**VILLAGE OF DOWNERS GROVE
REPORT FOR THE VILLAGE COUNCIL MEETING
MAY 15, 2012 AGENDA**

SUBJECT:	TYPE:	SUBMITTED BY:
Annexation with Rezoning to B-2, Lot Consolidation and Special Use for a drive-through use	<ul style="list-style-type: none"> ✓ Resolution ✓ Ordinance Motion Discussion Only 	Tom Dabareiner, AICP Community Development Director

A resolution and ordinances have been prepared for annexation, rezoning, lot consolidation and special use for a Walgreens store at the northwest corner of 63rd Street and Woodward Avenue.

To: Plan Commission
From: Jeff O'Brien, AICP, Planning Manager
Subject: PC-39-11, Annexation with Rezoning to B-2, General Retail Business, Final Plat of Subdivision for Lot Consolidation and Special Use for a drive-through use – Northwest corner of 63rd Street and Woodward Avenue
Date: January 9, 2012

TRUCK ROUTE PLAN
SCALE: 1" = 20'-0"

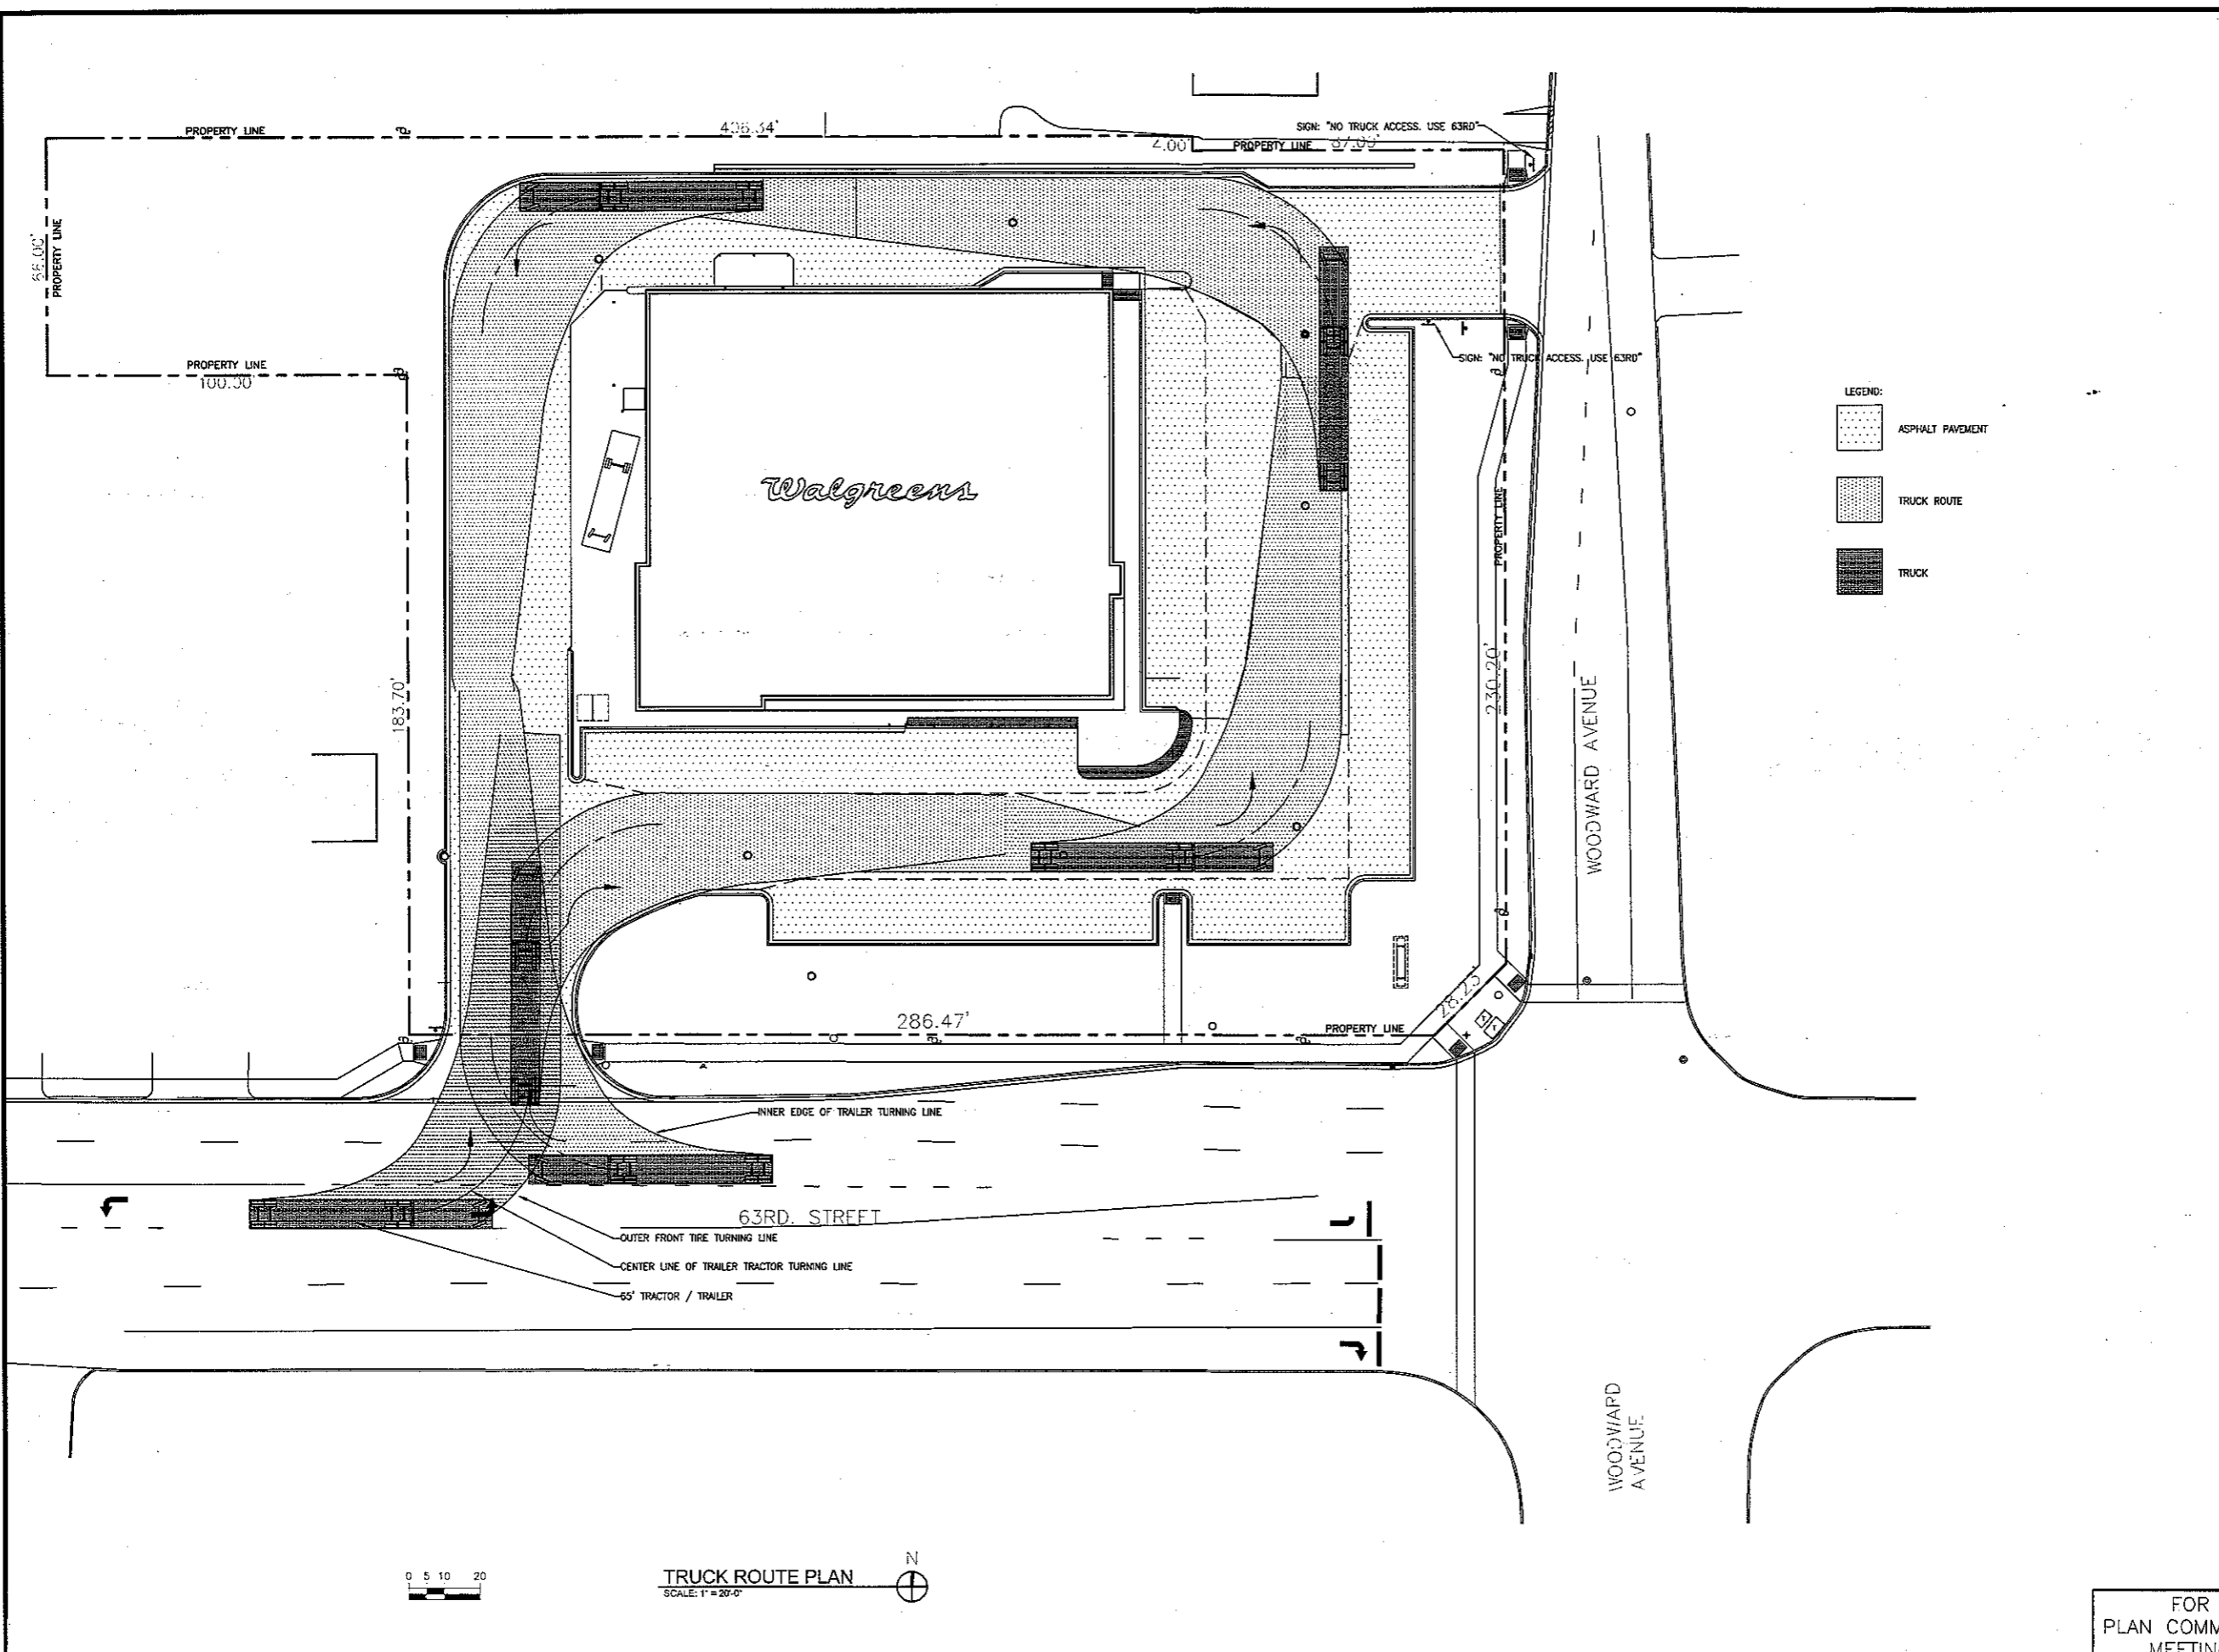
5. *Provide truck-access diagram*

The petitioner provided a truck-access diagram indicating trucks entering and exiting the site via 63rd Street. The drawings indicate that the trucks will be able to navigate the site without using Woodward Avenue. Woodward Avenue has a weight restriction, which would not allow for delivery trucks to use the street. The applicant is proposing additional signs on the property to inform drivers of these restrictions. Several minor adjustments (change in curb radii, adjustments to drive aisles, etc.) may be required to allow for better site circulation. Staff believes the site design is sufficient to allow for truck circulation without using Woodward Avenue. Staff would also offer the current Walgreens site at the northwest corner of 63rd Street and Belmont Road is significantly smaller than the proposed site. Delivery trucks successfully navigate this site even with the smaller dimensions.

Revised Landscaping Plan

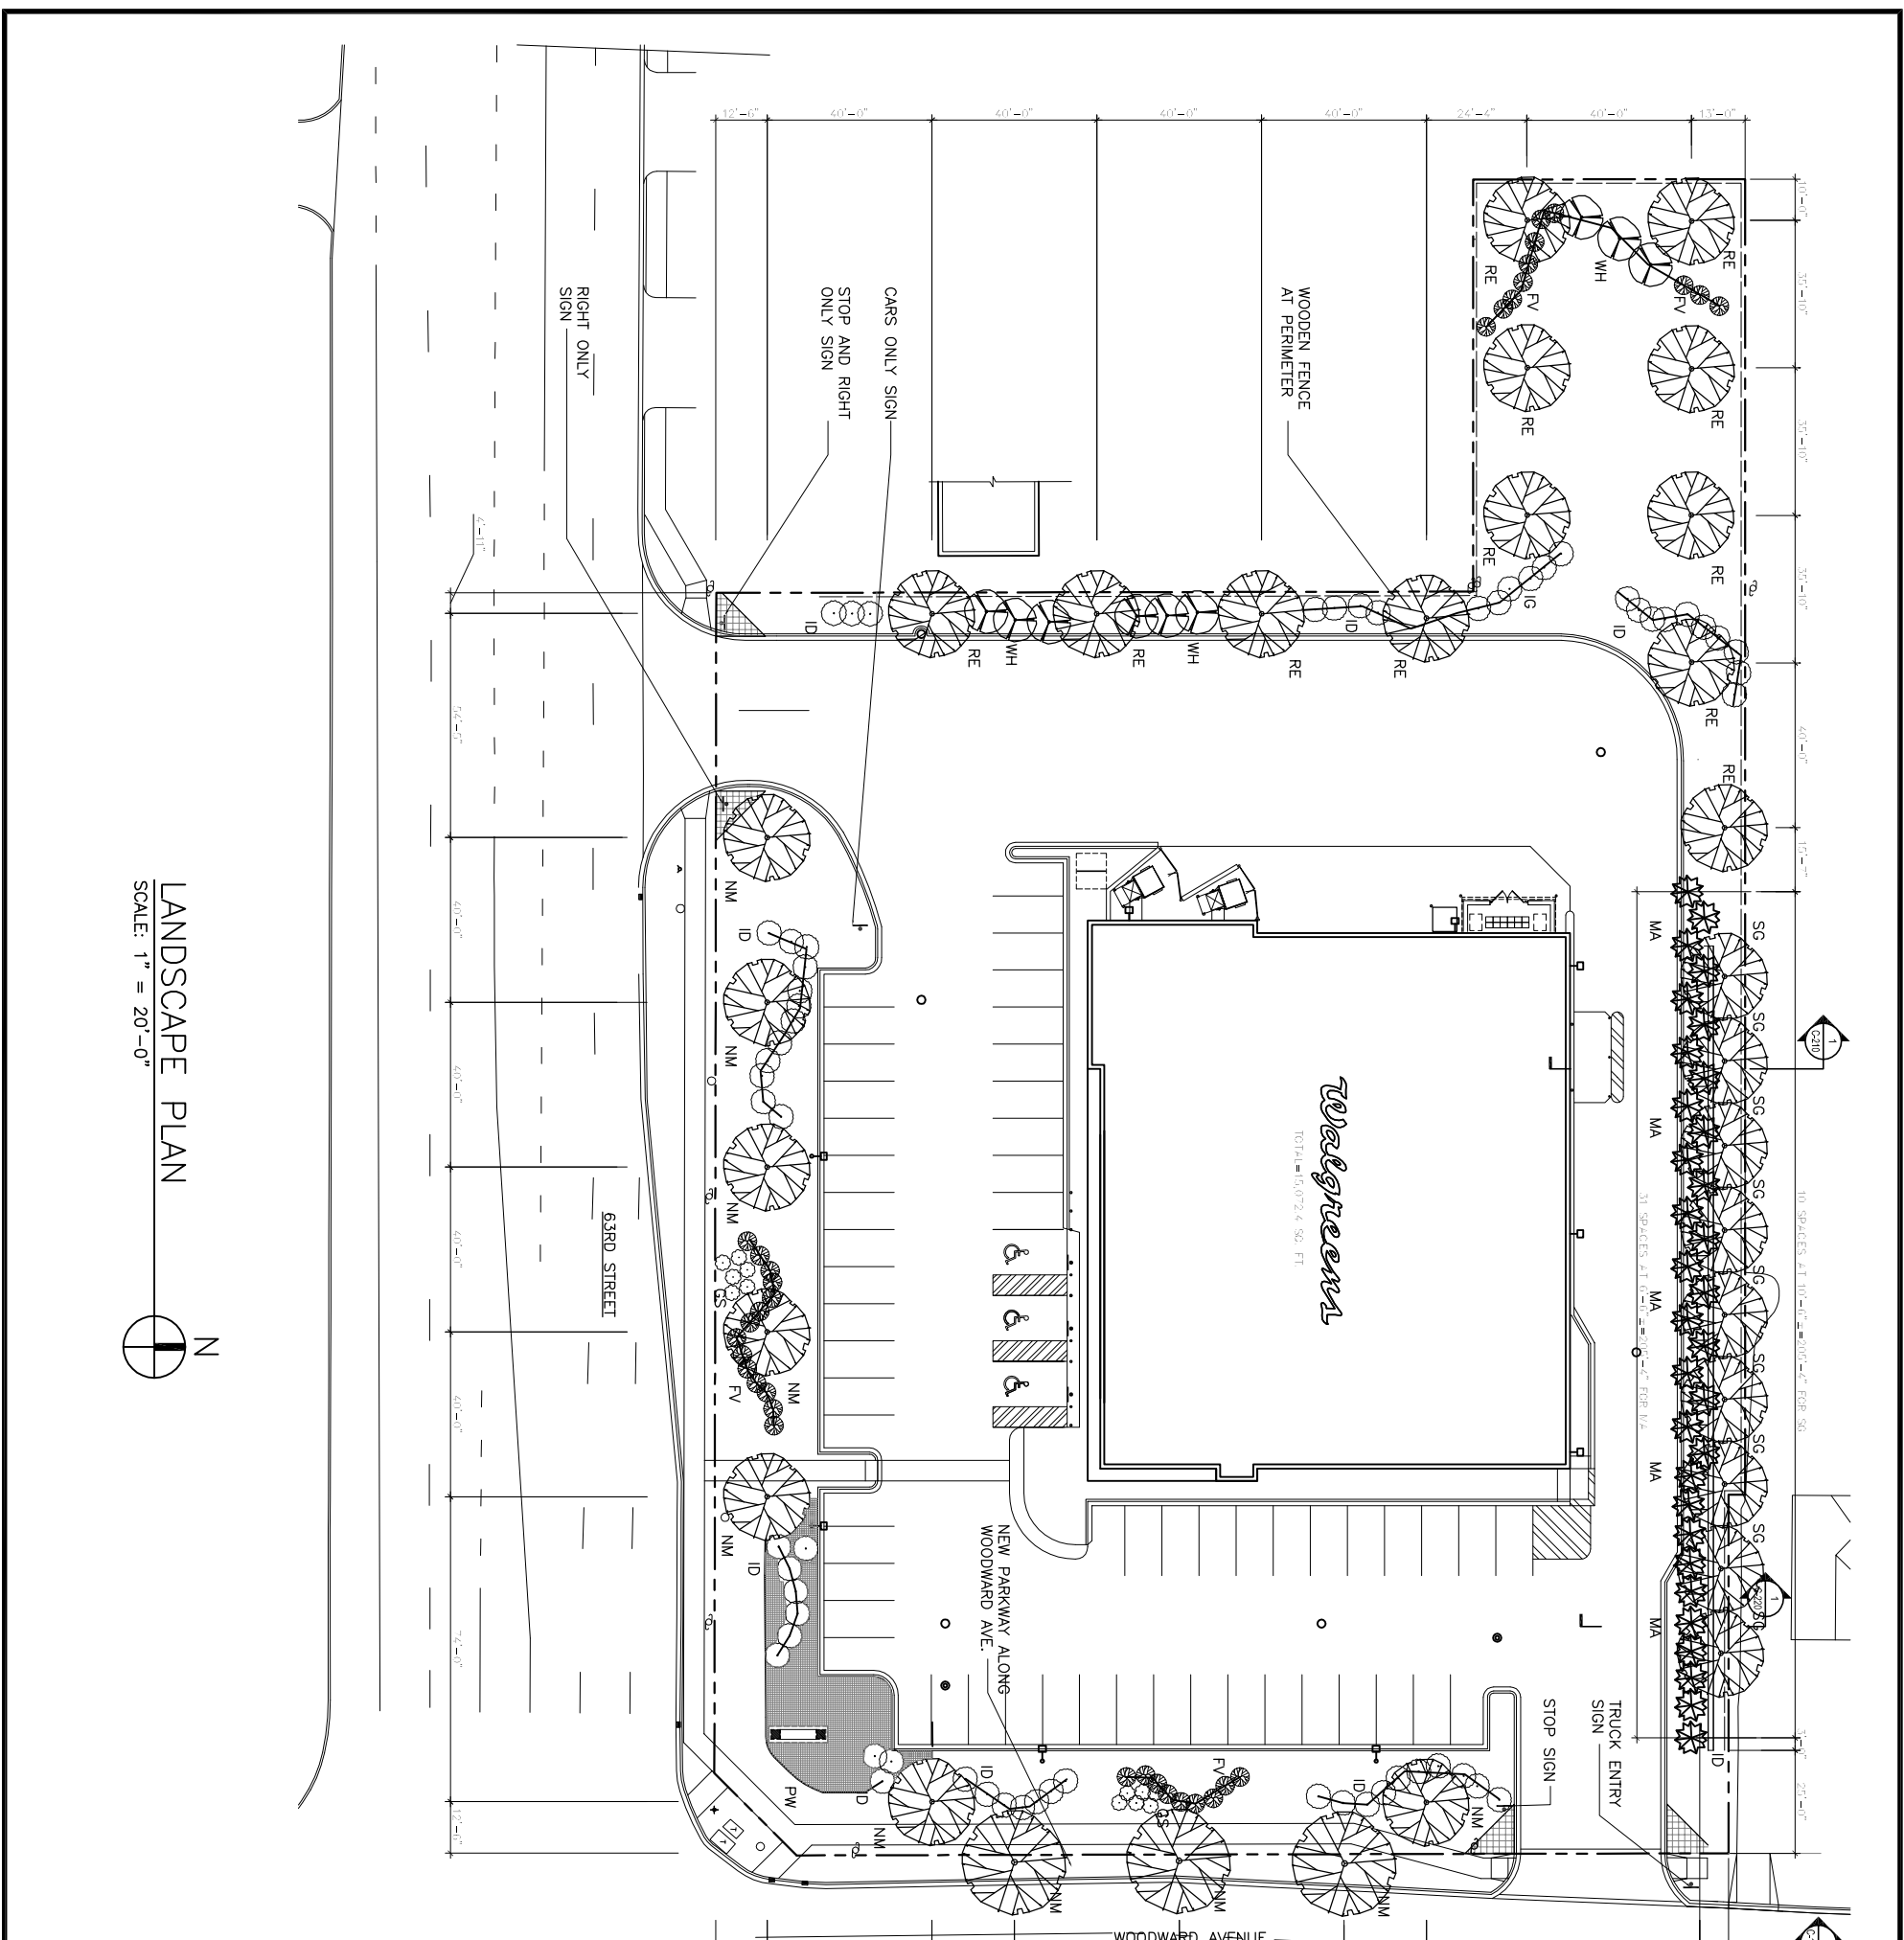
The proposed fence and landscaping will be still be installed along the north property line to screen the neighbor. However, they will not obstruct the use of the driveway or otherwise impede the access to the property. The plans have been revised to indicate the change in the north property line.
